## SERVICE BULLETIN

| Reference number: | SB-01-1011                                                                   | Issued: 16 April, 2018                         |
| Subject:          | Replacement of DB11 knee airbags                                             |                                                |
| Model(s):         | DB11                                                                         |                                                |

Figure 3

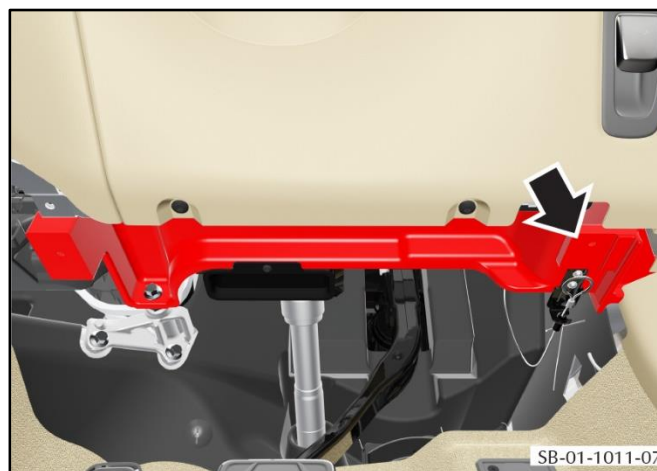
2. Identify the position where the outboard end of the driver knee airbag is attached to the cross-car beam assembly (refer to Figure 3).

Figure 4

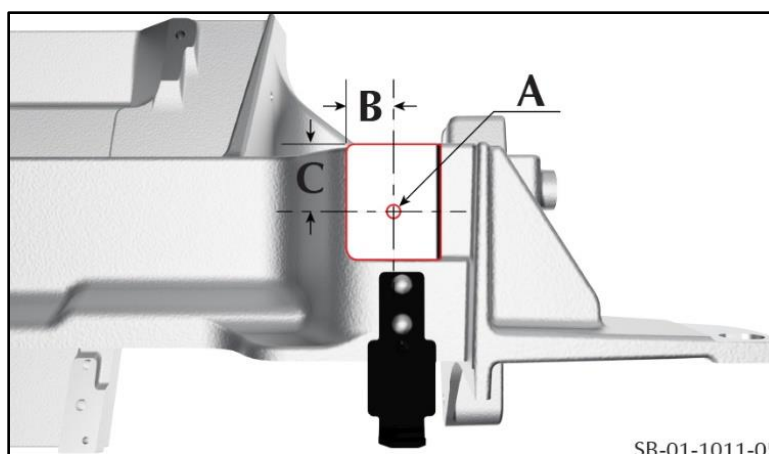
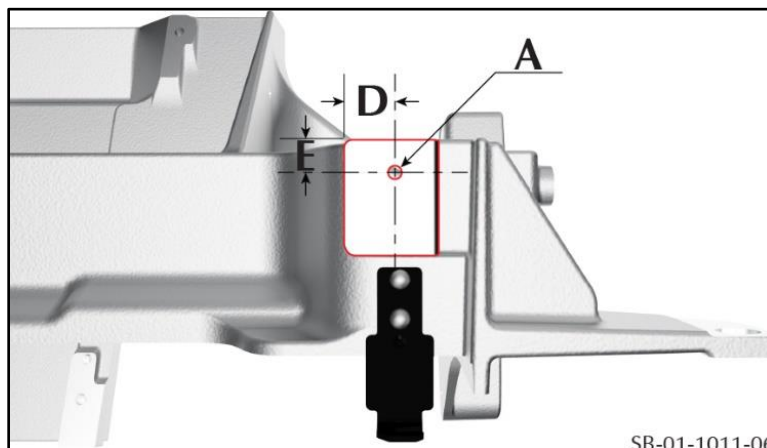
Figure 4 shows the initial design of the cross-car beam assembly. The hole (A) that has a thread for the M6 bolt is:

- 16.6 mm from the inboard edge (B)
- 23.3 mm from the rearward edge (C)

Figure 5 shows the new design of the cross-car beam assembly. The hole (A) that has a thread for the M6 bolt is:

- 17.6 mm from the inboard edge (D)
- 11.2 mm from the rearward edge (E)

3. Mark the position of the new hole center with a center punch and hammer (refer to the dimensions from Figure 5).
4. Make a 5.2mm hole through the cross-car beam assembly at the marked position.
5. Cut a thread for an M6 bolt in the hole – use lubricant as required.
6. Remove any rough edges and lubricant from the hole.
7. Do a check that the M6 bolt fits correctly in the new hole.
8. Install the new driver knee airbag (refer to Workshop Manual procedure 01.20.CN).

**Figure 6**

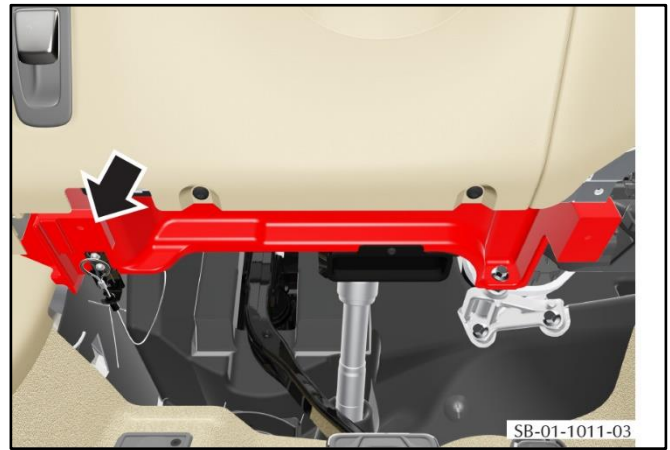
2. Identify the position where the outboard end of the driver knee airbag is attached to the cross-car beam assembly (refer to Figure 6).

**Figure 7**

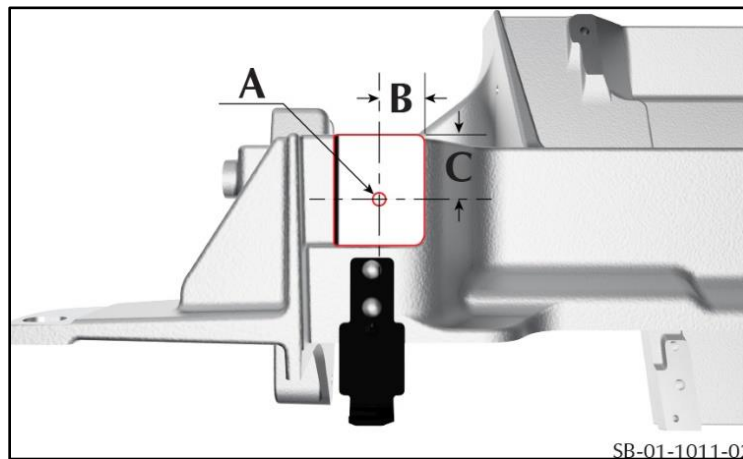
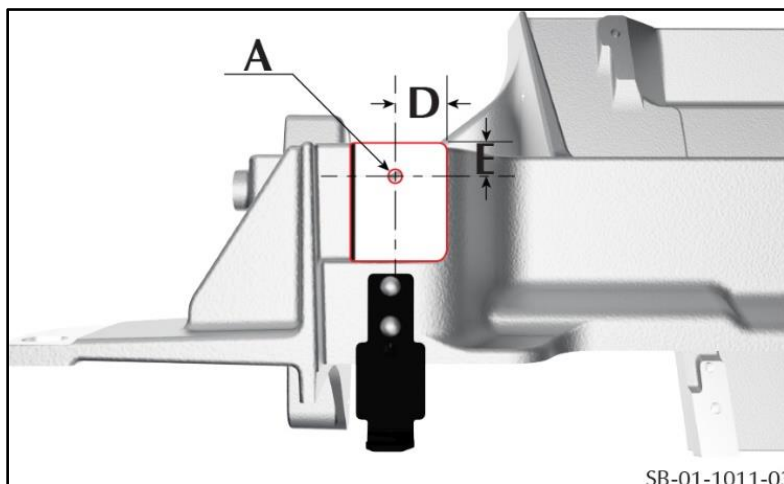
Figure 7 shows the initial design of the cross-car beam assembly. The hole (A) that has a thread for the M6 bolt is:

- 16.6 mm from the inboard edge (B)
- 23.3 mm from the rearward edge (C)

Figure 8 shows the new design of the cross-car beam assembly. The hole (A) that has a thread for the M6 bolt is:

- 17.6 mm from the inboard edge (D)
- 11.2 mm from the rearward edge (E)

3. Mark the position of the new design hole center with a center punch and hammer (refer to the dimensions from Figure 8).
4. Make a 5.2mm hole through the cross-car beam assembly at the marked position.
5. Cut a thread for an M6 bolt in the hole – use lubricant as required.
6. Remove any rough edges and lubricant from the hole.
7. Do a check that the M6 bolt fits correctly in the new hole.
8. Install the new driver knee airbag (refer to Workshop Manual procedure 01.20.CN).

**Figure 9**

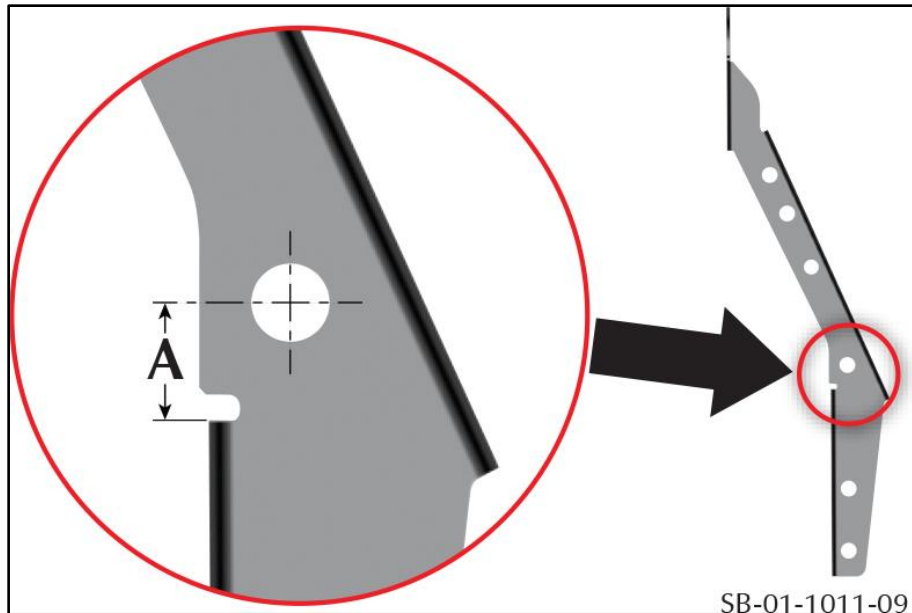
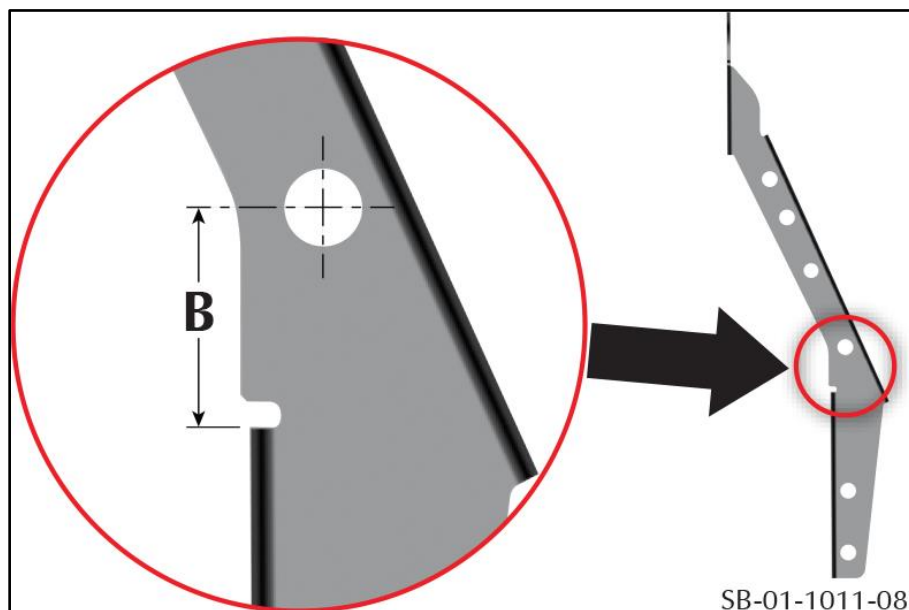
Figure 9 shows the initial design of the passenger knee airbag support bracket. Measurement “A” is 25mm.

Figure 10 shows the new design of passenger knee airbag support bracket. Measurement “B” is 37mm.

6. Install the new passenger knee airbag support bracket. Follow the above procedure in reverse from step 5 to 3.
7. Install the passenger's bottom panel for the instrument panel (refer to Workshop Manual procedure 01.12.DV).
8. Install the new passenger knee airbag (refer to Workshop Manual procedure 01.20.CP).

**Figure 11**

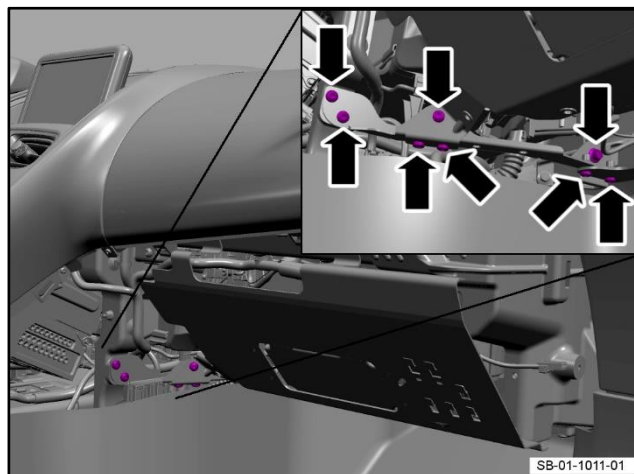
3. Remove the 8 bolts that attach the passenger knee airbag support bracket to the passenger knee protection plate and the IP assembly (refer to Figure 11).

**Figure 12**

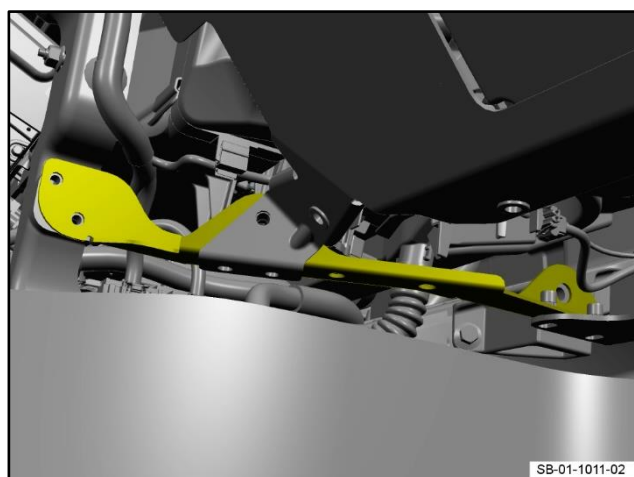
4. Carefully lift the passenger knee airbag support bracket away from the passenger knee protection plate and the IP assembly (refer to Figure 12).

**Figure 13**

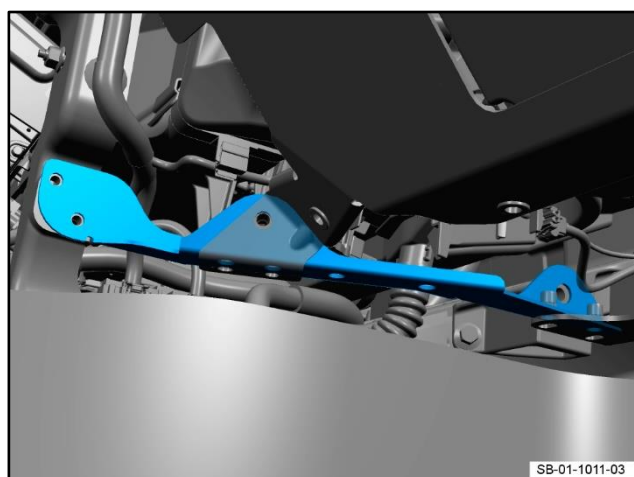
5. Remove the passenger knee airbag support bracket (refer to Figure 13).
